Access Compliance Report

Public Rights-of-Way

Intersection ID: 16751	Main Street: PRINCETON_AV	Cross Street: QUEENS_RD_WEST	Location: SW
ADA ID: 307DD9603301	Ramp Type: Perp	Initial Pass/Fail: Fail	Overall Compliance: No
		Severity Score: 12.5

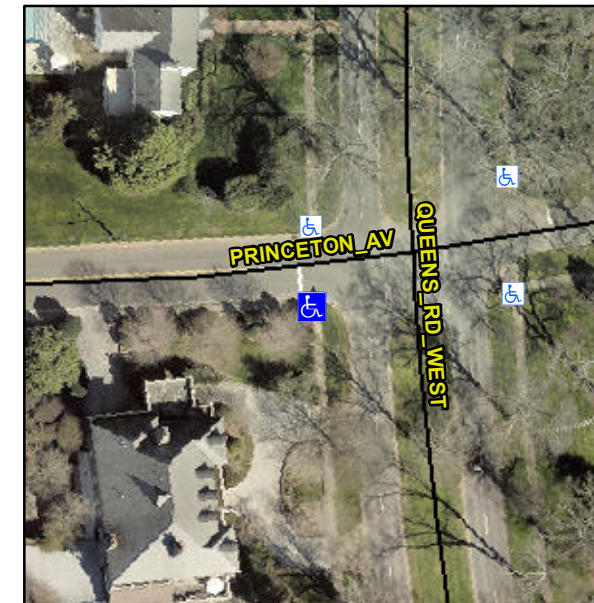
Not Found, R304.2.2

Compliance	Description	Data	Compliance	Description	Data
N/A	Ramp Length (in)	36.0	No	Ramp Slope (%)	11.1
Yes	Ramp Width (in)	48.0	Yes	Ramp XSlope (%)	1.6
N/A	Flare Type LT	N/A	N/A	Flare Type RT	N/A
N/A	Flare Slope LT (%)	N/A	N/A	Flare Slope RT (%)	N/A
N/A	Flare Traversable LT?	N/A	N/A	Flare Traversable RT?	N/A
N/A	Landing Length (in)	N/A	N/A	DWS Provided?	N/A
N/A	Landing Width (in)	N/A	N/A	DWS Contrast?	N/A
N/A	Landing Slope (%)	N/A	N/A	DWS Length (in)	N/A
N/A	Landing X Slope (%)	N/A	N/A	DWS Full Width?	N/A
N/A	Landing Curb? (Y/N)	N/A	N/A	DWS Offset (in)	N/A
N/A	Shared Landing?	N/A			
N/A	Gutter Ponding?	N/A	N/A	Gutter Slope (%)	N/A
N/A	Gutter Lip Ht (in)	N/A	N/A	Gutter X Slope (%)	N/A
N/A	Painted X Walk1?	No	N/A	Painted X Walk2?	N/A
	X Walk 1 Direction	To N		X Walk 2 Direction	N/A
N/A	X Walk 1 Width (in)	N/A	N/A	X Walk 2 Width (in)	N/A
	X Walk 1 Slope (%)	4.0		X Walk 2 Slope (%)	N/A
	X Walk 1 X Slope (%)	0.5		X Walk 2 X Slope (%)	N/A

Remove & Replace Entire Ramp.
